**AMENDMENT TO**  
**GARDEN OF EATON LOCAL STRUCTURE PLAN**  
**AGREED STRUCTURE PLAN 27 JANUARY 2010**

**AMENDMENT TO  
GARDEN OF EATON LOCAL STRUCTURE PLAN  
AGREED STRUCTURE PLAN 27 JANUARY 2010**

#### STRUCTURE PLAN AMENDMENT REPORT

Figure 1  
 GULLY PRECINCT

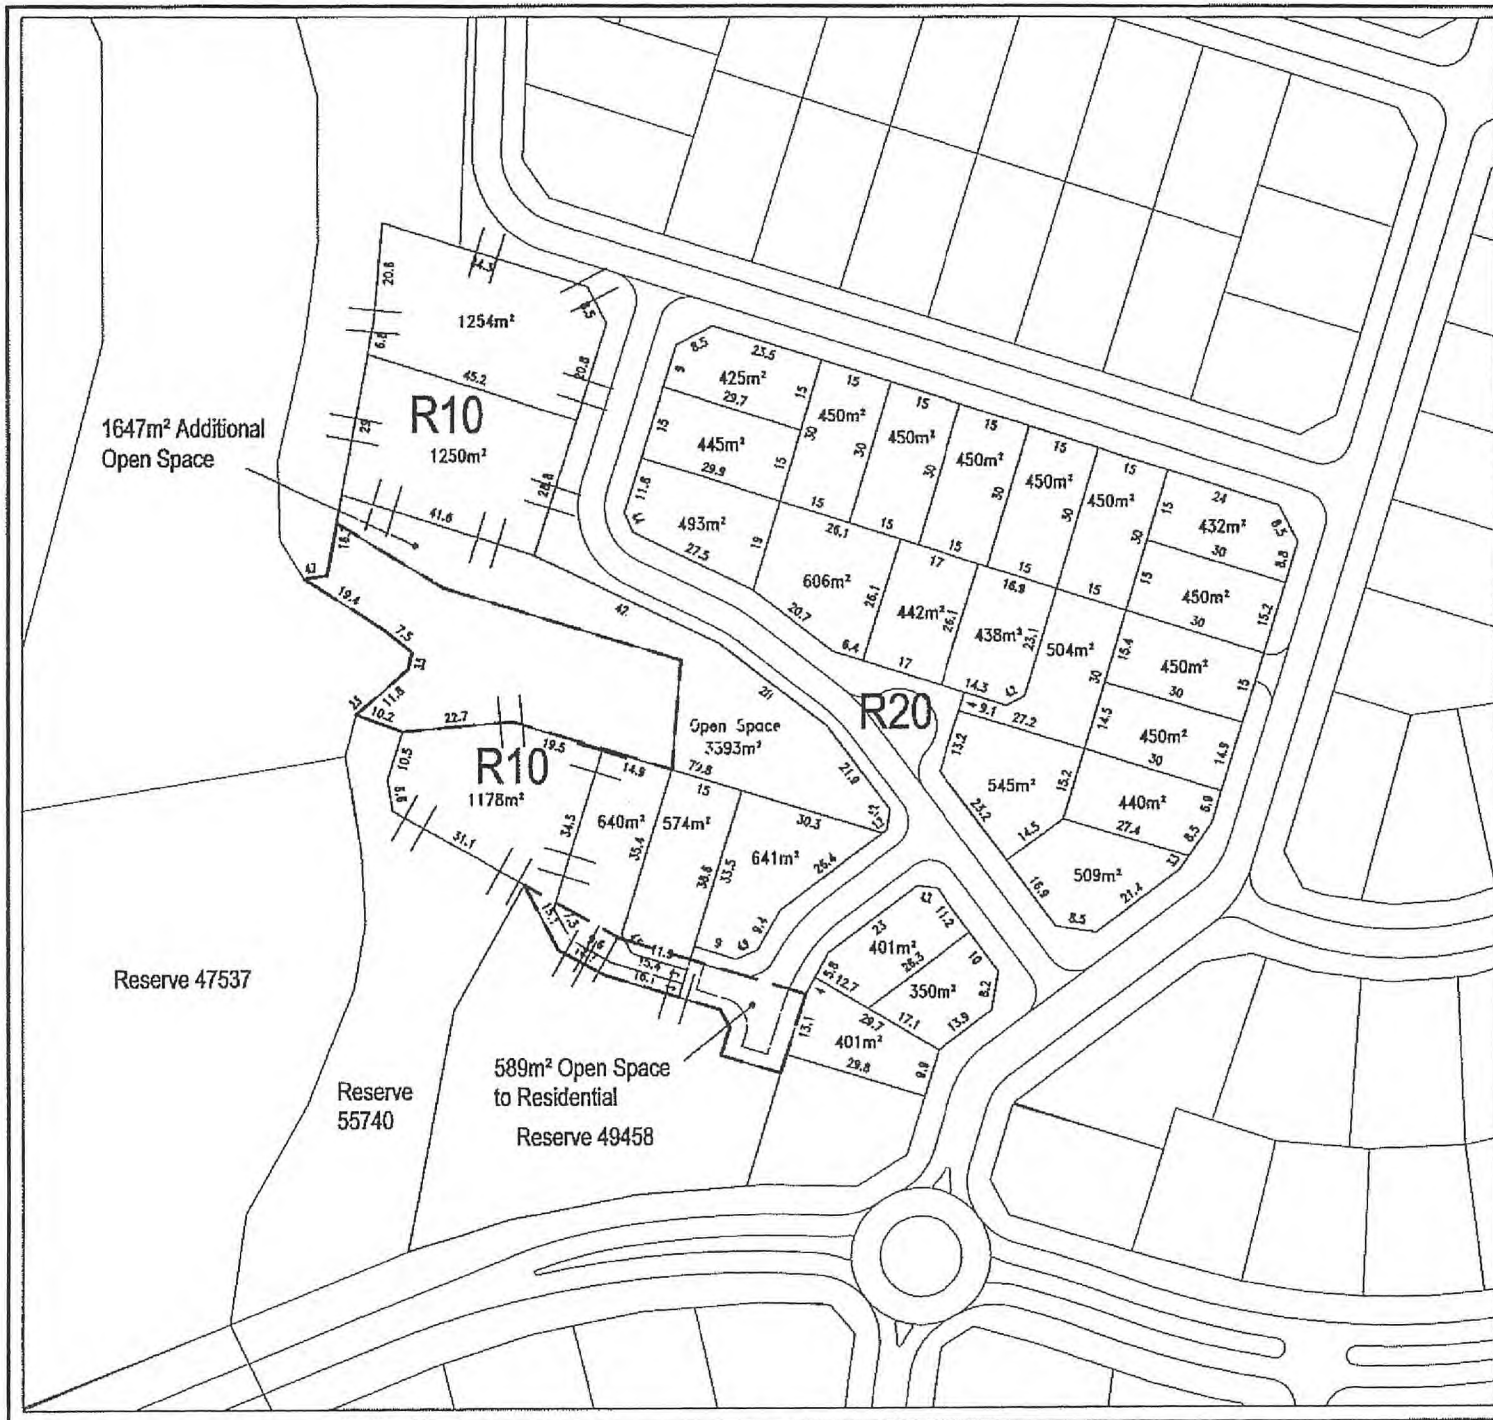
- 3.1.1 There is an agreed Structure Plan covering the Millbridge area. This proposal departs from the existing Structure Plan by changing the local road system marginally in order to protect an attractive gully (refer to **Figure 1**).

- 3.1.2 The modifications maintain the existing density coding within the Structure Plan, with R10 lots abutting the Creek reserve and R20 lots for the balance. There is no increase in the number of lots and all lot sizes comply with the relevant density coding.

- 3.1.3 The modifications include an overall increase in the provision of public open space and protection of an attractive, natural gully feature. It is proposed to extend the current "Recreation" zone to the east and include a greater area of the gully, which requires a change in the zoning from "Residential" to "Recreation". The use of the gully was previously specified for private recreation use in a grouped housing development, but will now be accessible to all members of the public.

To achieve the protection of this natural asset, a portion of Reserve 49458 zoned for "Recreation" at the southern extent of the Gully Precinct will be required as "Residential". The table below shows the area of land involved and the overall increase in Public Open Space:

Land Parcel	Zoning Change	Area
Gully	Residential to Recreation (Public Open Space)	1647m <sup>2</sup>
Southern extent	Recreation to Residential (Reserve 49458)	589m <sup>2</sup>

The portion of Reserve 49458 proposed to change to "Residential" is only 589m<sup>2</sup> in area. The additional Recreation reserve proposed contains the high quality environment of the gully and measures 1647m<sup>2</sup>.

The subdivision layout indicates that the portion of land in the south that is proposed to change from "Recreation" to "Residential" will be used for the local road network and access legs to adjoining lots. The road layout will ensure that good access to POS from the lots north of Millbridge Boulevard will be achieved.

- 3.1.4 The extension of the "Recreation" zone results in modifications to the road network and an improved movement system. The existing Structure Plan design indicated a strata proposal over a portion of the gully and surrounds, which restricted both vehicular and pedestrian north-south movement, encouraging the use of Hatfield Way only or the Millar's Creek foreshore.

The proposed road layout introduces a public street from the subdivision road north of the Gully Precinct, linking to Hatfield Way at the south of the area. A second access street

with a turning head provides increased access to the Recreation area to the south. The permeability of the road network will increase mobility and is in accordance with Liveable Neighbourhoods principles. For lots to the north of the Gully Precinct, the road distance to the Reserve 49457 in the south is significantly decreased from 380m to 210m, indicating greater potential for accessibility.

Lot 1005 is an existing stand-alone property abutting the southern boundary of the Gully Precinct. Under the approved strata scheme, it was intended that parking bays be provided, via a laneway off Hatfield Way and adjoining Lot 1005, for users of the adjacent POS. The current proposal removes the parking bays and the laneway, providing a road to the north and associated street parking instead.

The proposed road to the north of Reserve 49458 provides vehicular access to four lots only, so traffic levels on that road are expected to be low. Street parking for users of the reserve can be accommodated within the road reserve without interfering with the traffic flow or access to properties and accordingly, there is no necessity to have bays formally marked for that purpose.

Figure 3

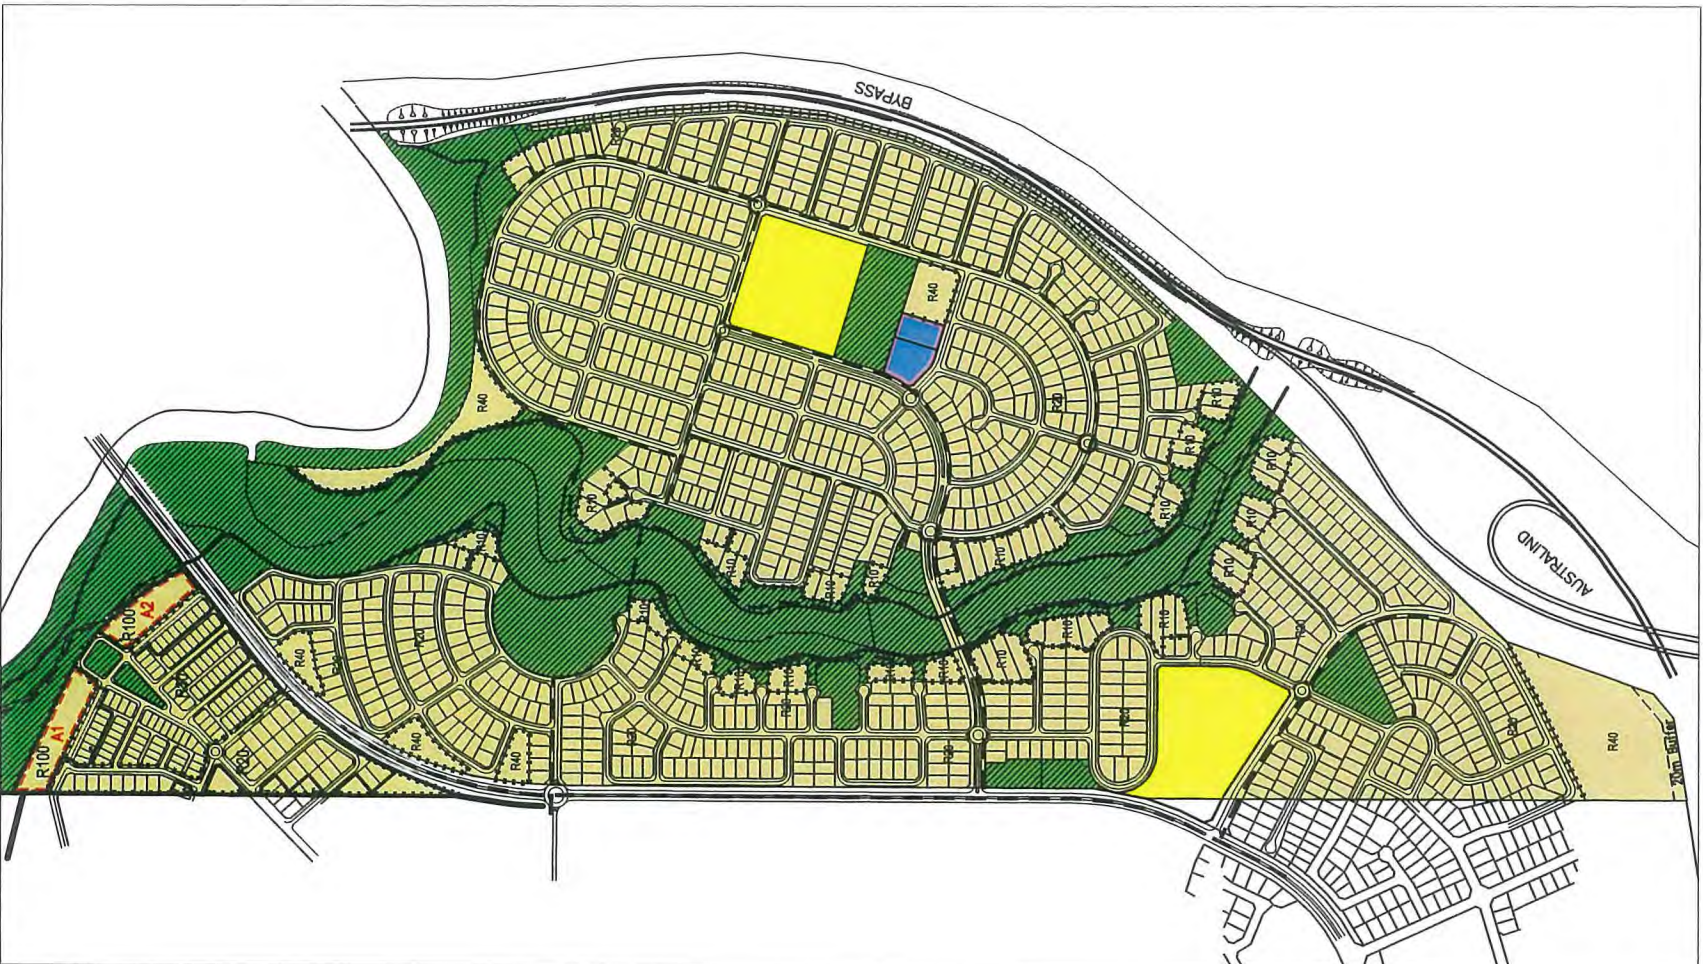
- e) Adjusting the boundary of the Recreation Reserve of the Millar's Creek Foreshore Reserve in the East Millbridge locality;
- f) Increasing the land shown for "Recreation" use on the foreshore of Millar's Creek;
- g) Adjusting the residential density R Code boundaries for land adjacent to the Millar's Creek foreshore reserve;
- h) Adjusting the pattern of residential subdivision for land adjacent to the Millar's Creek foreshore reserve;

3.2.1 There is an agreed Structure Plan covering the Millbridge area. This part of the proposal departs from the existing Structure Plan by changing the local road system marginally in order to simplify the access to lots and change tenure (refer to **Figure 2**).

3.2.2 The modifications rationalise the existing density codings from the Structure Plan, utilizing the density codings more effectively to increase the overall number of lots and increasing the amount of POS. Battleaxe lots are deleted from the plan in line with advice relating to fire management and all lot sizes comply with the relevant density coding.

3.2.3 The proposed amendment results in an increased lot yield from ten to <sup>elevated</sup> ~~seven~~. There is three less R10 sites and four more R20 sites, with the balance of land being incorporated into an extended road reserve and Recreation reserve. The following table summarises the changes:

Existing	Proposed
R10	6 lots	3 lots
R20	4 lots	8 lots
Recreation	An additional 1125m <sup>2</sup> added to Recreation reserve

3.2.4 The modification to the road layout includes extending a cul-de-sac northwards, providing the majority of lots with greater road frontage for easy access. The changes result in more regularly shaped and larger lots that will be easier to build on. They will also enable formation of a more continuous and regular streetscape and it is envisaged that the changes will enable more efficient servicing in terms of water, sewerage and power.
